FORD 4R100 "UPDATE HANDBOOK"

FORD 4R100 "UPDATE HANDBOOK"

Since the introduction of the 4R100 transmission in model year 1998, there have been many engineering changes to improve Pleaseability, Reliability and Durability concerns. These changes have affected most every part used in this transmission. This "Update Handbook" will explain each change, the reason for the change, and any parts interchangeability concerns created by the change, along with any part numbers needed to update your transmission.

Figure 15

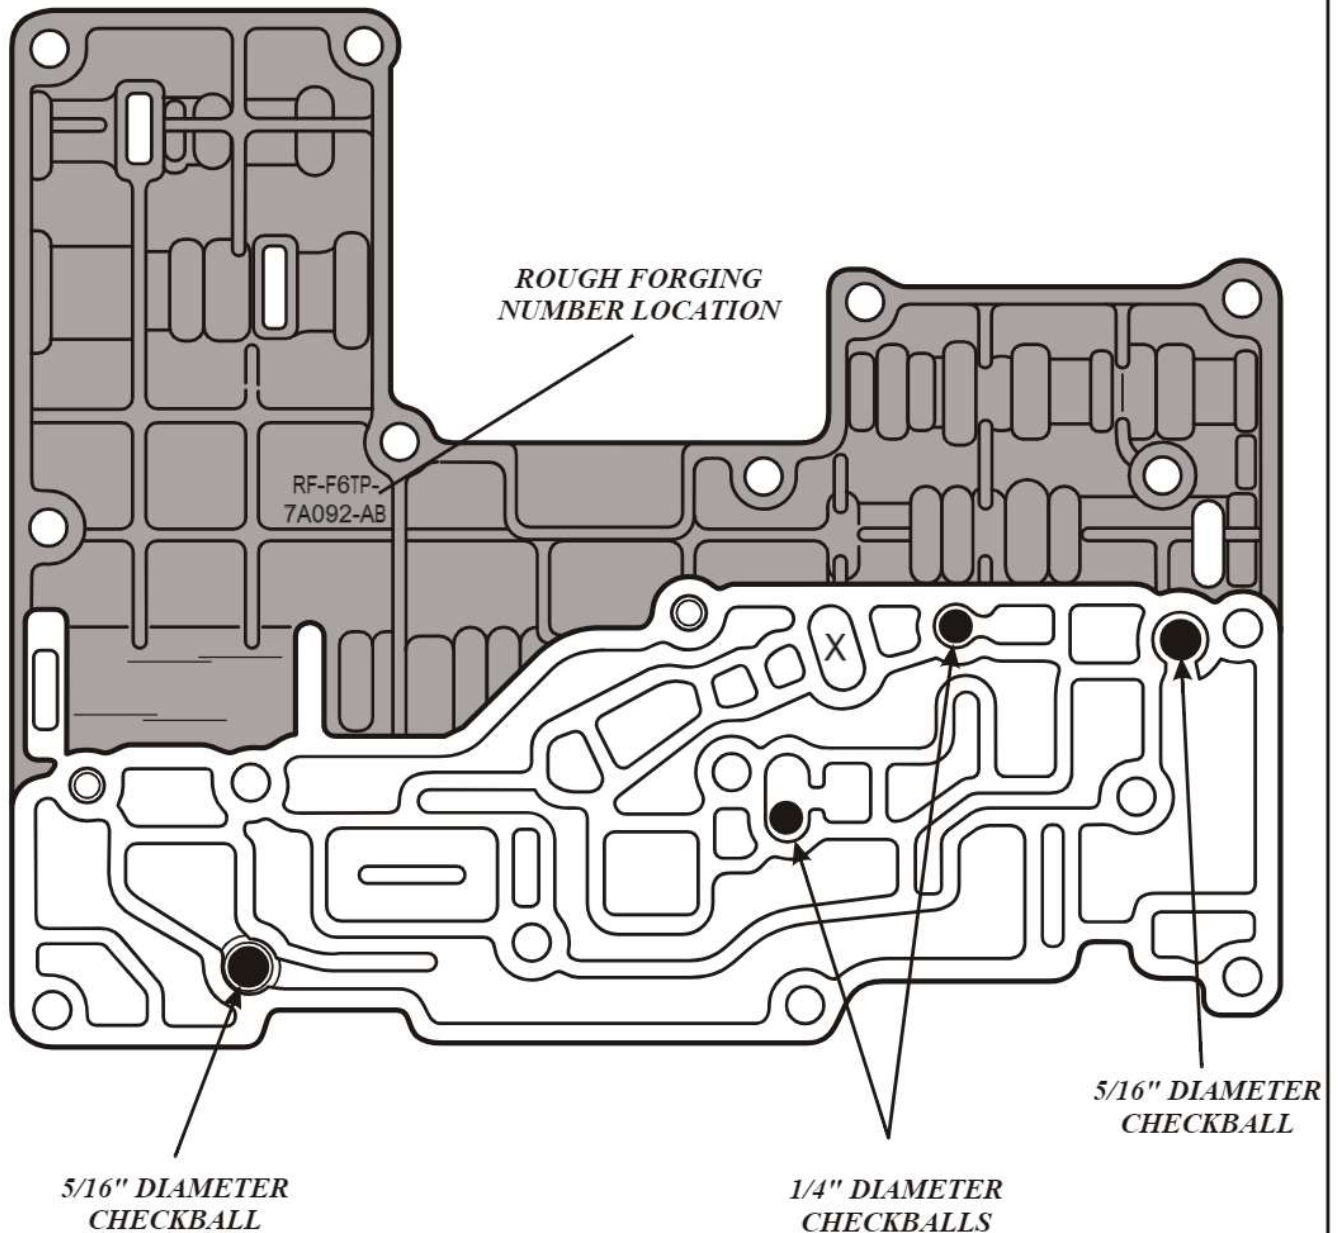
- (15) **VALVE BODY CHECKBALL LOCATIONS** - Valve body checkball locations are illustrated in Figure 15 and now has two 1/4" checkballs and two 5/16" checkballs. This of course changes the lower valve body spacer plate as illustrated in Figure 16. The new design spacer plate has only one hole over the bathtub where the checkball was removed. The case checkball locations remain the same as the 1996-Up configuration, and this illustration is included for reference and shown in Figure 17.

**4R100 VALVE BODY CHECKBALL LOCATIONS
REQUIRES TWO 1/4" RUBBER BALLS,
AND TWO 5/16" RUBBER BALLS**

Figure 30

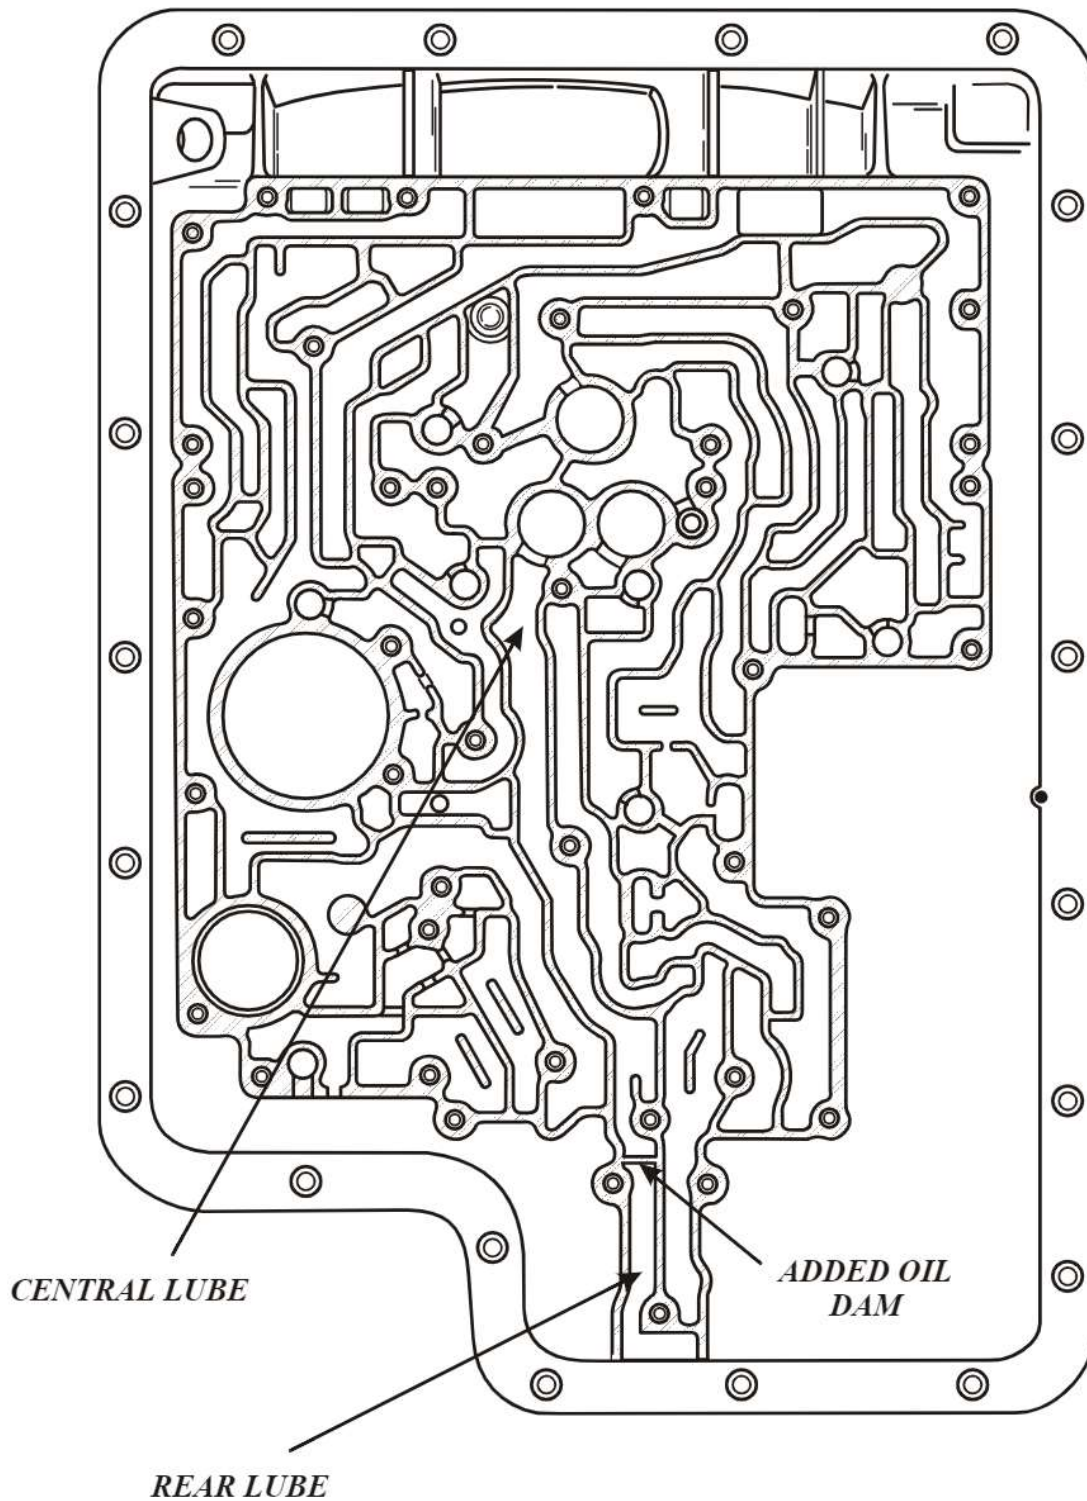
- (1) **TRANSMISSION CASE:** The transmission case was changed to accommodate the "PTO" window, as previously shown in this manual. All 4R100 Cases, "NON-PTO" and "PTO," also had a "Dam" added to separate "Rear Lube" and to incorporate "Central Lube" as shown in Figure 30.

Figure 32

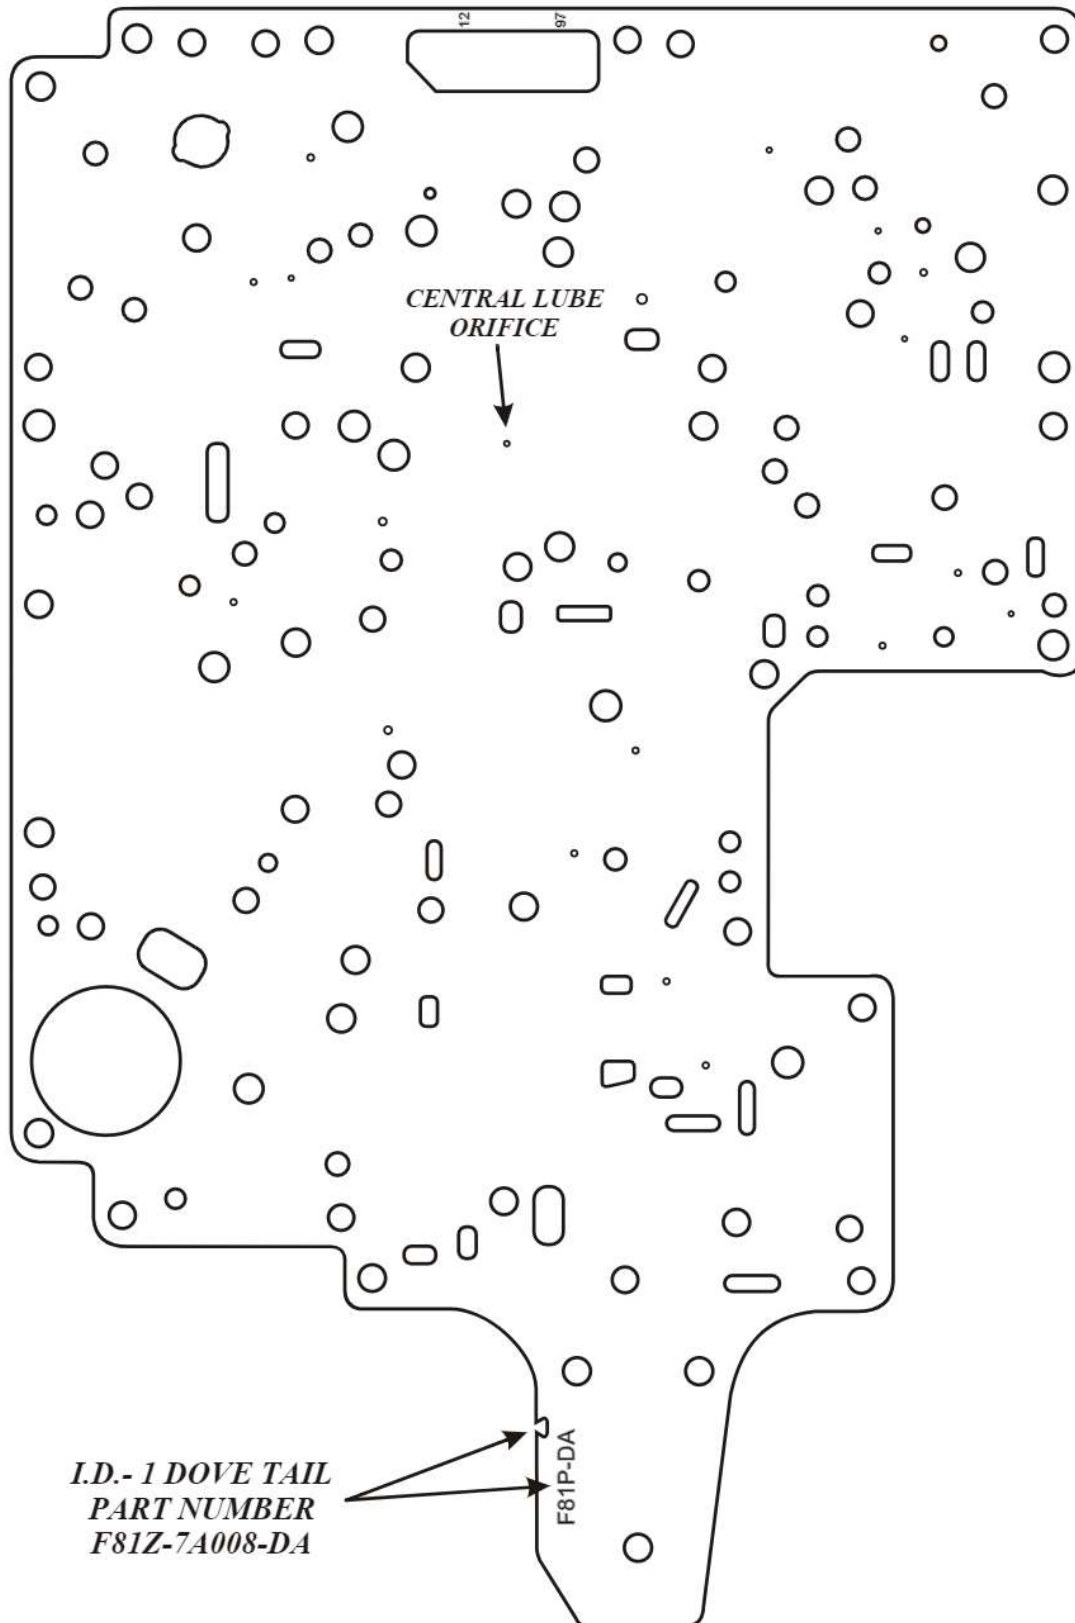
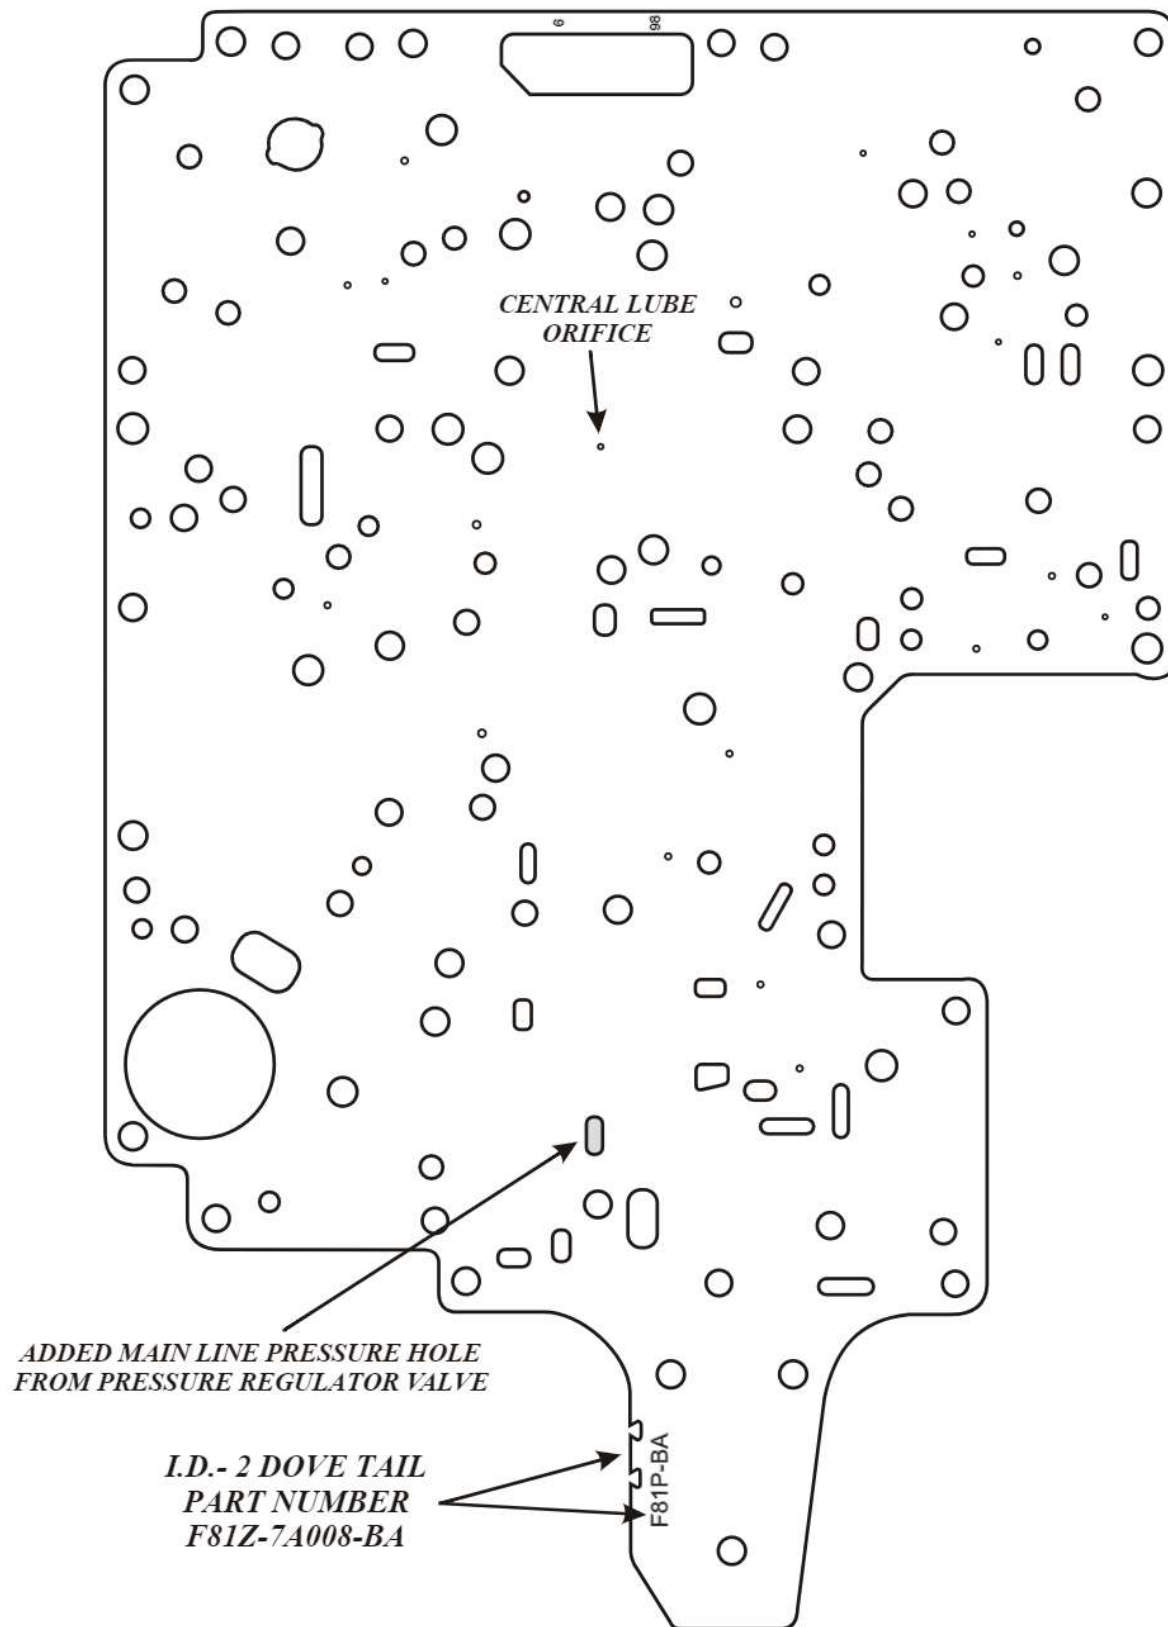
- (2) **VALVE BODY TO CASE SPACER PLATE:** The Valve Body to Case Spacer plate on the "PTO" versions had a hole added, to supply the 3-4 Shift Valve with Line Pressure, as shown in Figure 32. A hole was also added to the Spacer Plate on "NON-PTO" and "PTO" versions to connect "Solenoid Regulator Valve" oil to supply "Central Lubrication." Refer to Figures 31 and 32 for identification of "NON-PTO" and "PTO" Valve Body To Case Spacer Plates.
